## **HAAS AT THE HILL SUBDIVISION**

Engineering Comments: FINAL PLAT COMMENTS (should be addressed prior to submitting the FINAL PLAT for review and/or signature by the City Engineer):

APPLICATION NUMBER 6 DATE June 17, 2021

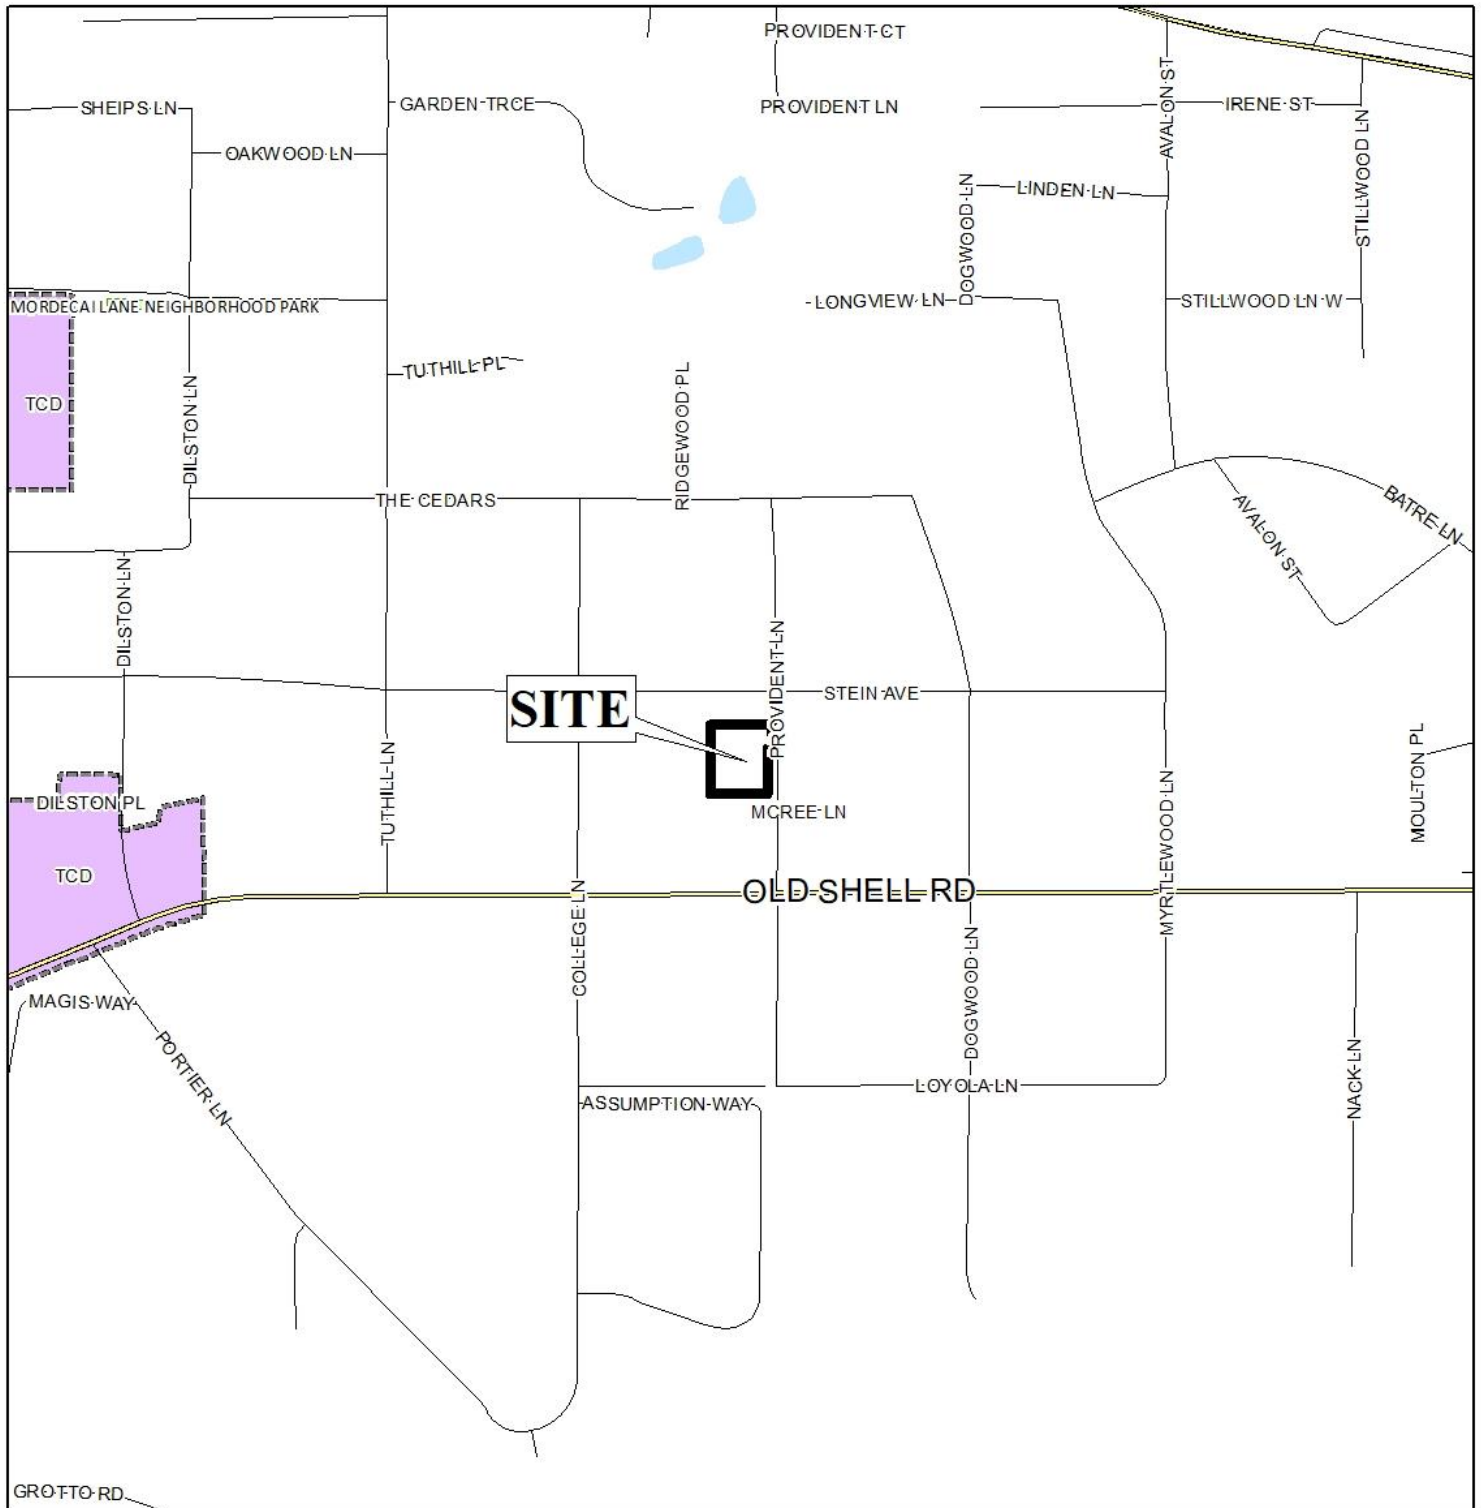
The subject site consists of Lots 1 and 2, Haas Addition to Springhill Subdivision, approved by the Commission in 1997, and a metes-and-bounds parcel. The site has frontage on Provident Lane, a minor street with curb and gutter, but with a noncompliant 41.5-foot right-of-way. A 50-foot right-of-way is required for such. Dedication to provide 25 feet from the centerline of Provident Lane was required with the recording of the two-lot Haas Addition to Springhill Subdivision. However, the metes-and-bounds parcel constituting the North third of the site extends to within approximately 16.5 feet of the centerline of Provident Lane. The preliminary plat indicates a dedication of 8.47 feet is to be provided along this parcel to provide 25 feet from the centerline of Provident Lane, and this should be retained on the Final Plat, if approved.

The plat indicates a 25-foot minimum building setback line along Provident Lane from the current right-of-way of existing Lots 1 and 2, Haas Addition to Springhill Subdivision, and from the future right-of-way line of the current metes-and-bounds parcel, after dedication. Thus, the 25-foot minimum building setback line should be retained on the Final Plat. The proposed lots meet the minimum size requirements of the Subdivision Regulations. As on the preliminary plat, the lot size labels in both square feet and acres should be retained on the Final Plat, after required dedication, or a table should be furnished on the Final Plat providing the same information.

There is an existing dwelling on the proposed Northern lot which does not meet the current side yard setback requirements on the existing metes-and-bounds parcel. As the metes-and-bounds parcel is proposed to be expanded to the South to form new Lot 1, the Final Plat should be revised to indicate at least an eight-foot side yard setback along the South property line for walls and/or columns of the porch/house, and at least a six-foot setback for eaves/overhangs, in compliance with Section 64-3.C.1.e. of the Zoning Ordinance.

As per the Traffic Engineering comments, the driveway number, size, location, and design are to be approved by Traffic Engineering and conform to AASHTO standards. A note should be required on the Final Plat stating these comments.

- 1) retention of the dedication to provide 25 feet from the centerline of Provident Lane on the Final Plat;
- 2) retention of the 25-foot minimum building setback line on the Final Plat;

- 3) retention of the lot size labels in both square feet and acres on the Final Plat, adjusted for any required dedication, or the furnishing of a table on the Final Plat providing the same information;

- 4) revision of the plat to indicate at least an eight-foot side yard setback along the South property line for walls and/or columns on the existing dwelling on proposed Lot 1, and at least a six-foot setback for eaves/overhangs, in compliance with Section 64-3.C.1.e. of the Zoning Ordinance;

- 6) placement of a note on the Final Plat stating the Traffic Engineering comments: *(Driveway number, size, location, and design to be approved by Traffic Engineering and conform to AASHTO standards);*
